Subject: [EXTERNAL] Commercial and Residential Developers Stakeholder Meeting 9/7/23

RE: City of Port St. Lucie Text Amendment Chapter 156 – Subdivision Regulations, Section 156.094 and Chapter 158 – Zoning Code, Section(s) 158.172, 158.187 & 158.222 P23-113

RE: P23-113 City Initiated Text Amendment re Secondary Access Standard

RIVERLAND PARCEL C
66 NON-MODEL UNITS STARTED
(1/2021)
+ 24 permits / 2wks "ready to go"
= 90 PERMITS ISSUED

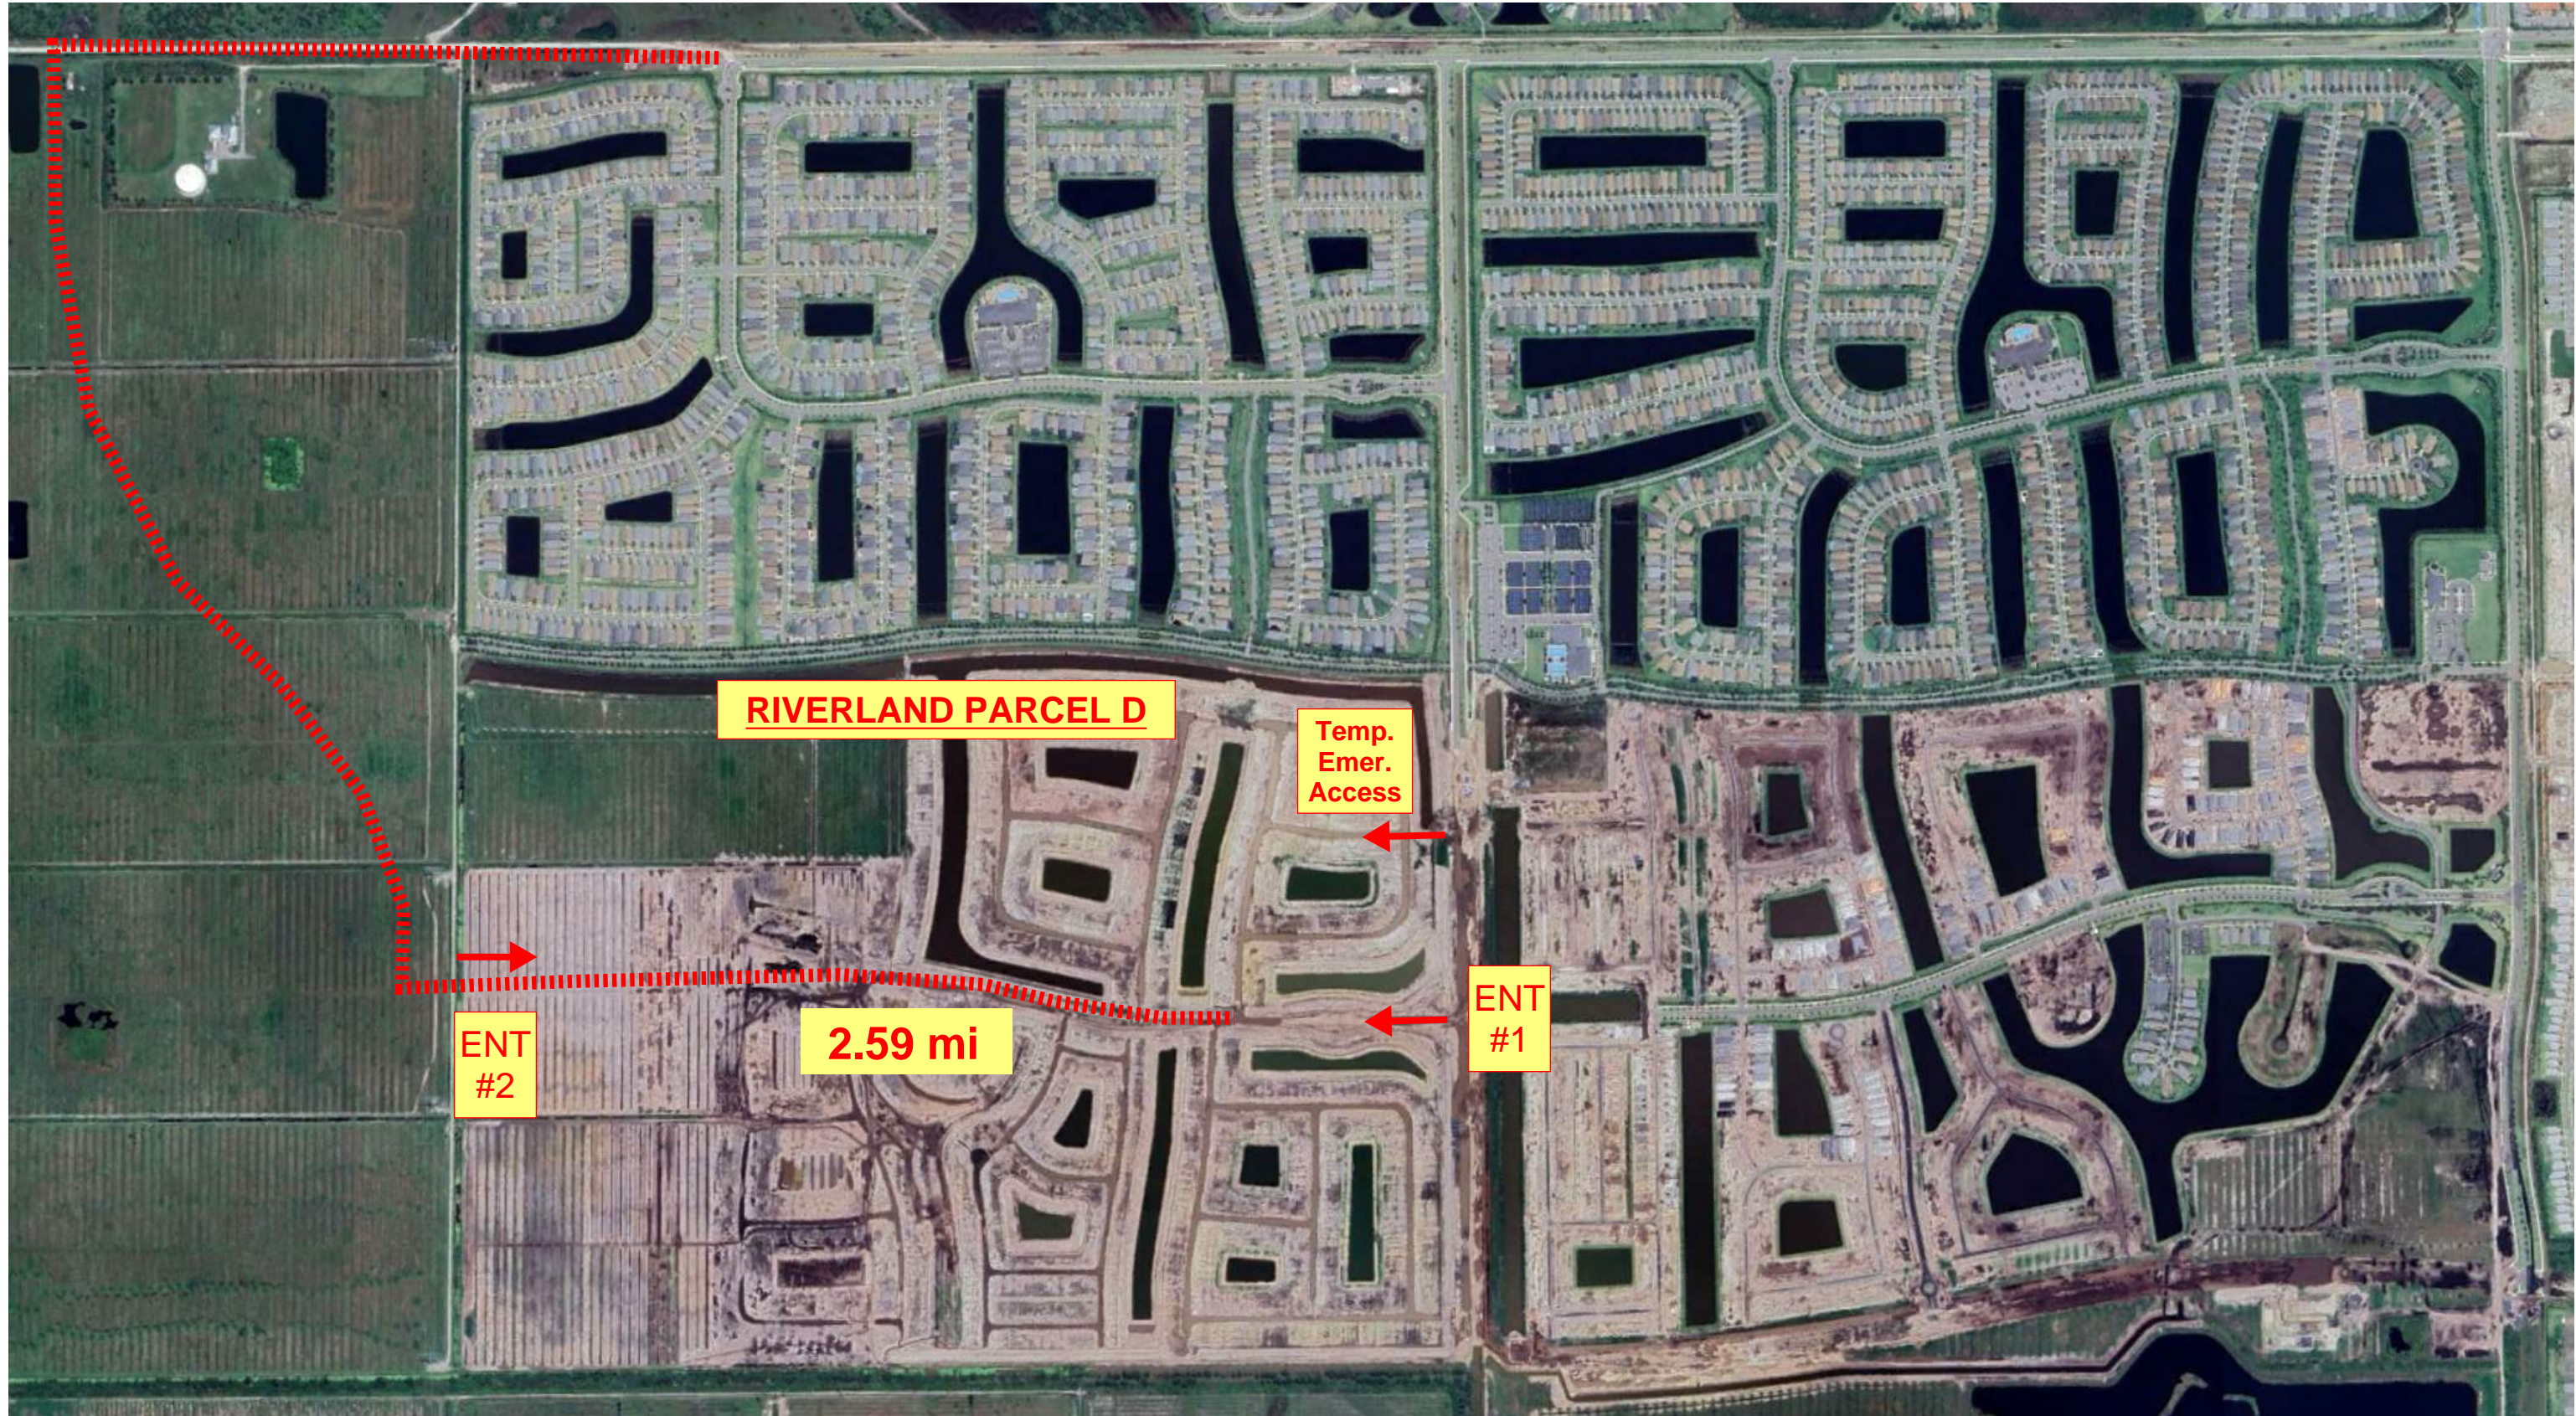
On behalf of Riverland/Kennedy II, LLC (referred to herein as “GL”), we support of the City’s efforts to codify minimum vehicular access standards for residential developments. As you can see in the attached graphics that depict the beginning stages of our four (4) approved residential parcels (Parcels A through D), we are implementing the very access standards that the City seeks to codify. Each of our residential development subdivisions have two (2) permanent access points on two (2) different roadway frontages. Additionally, we provide a permanent access point (at the main entry to a community) and a temporary emergency secondary access point before the first certificate of occupancy is issued. While we agree that standards should be codified, GL is not supportive, however, of the current Staff proposal.

For those larger-scaled developments that have over 500 homes, and especially those that have over 1,000 homes in a single community (like those in Riverland), it is unrealistic to expect a permanent secondary access gets developed prior to the issuance of the 75th building permit. If we were required to follow this 75th building permit standard, the secondary access points for each of our communities would lead to undeveloped land and remain as a road connection to nowhere, which would be confusing for emergency response vehicles (and residents) and would serve no purpose as there would be no physical internal connection between the two access points.

Rather, we suggest the City consider a threshold standard based on a percentage of building permits issued as this approach can be applied to developments of varying sizes.
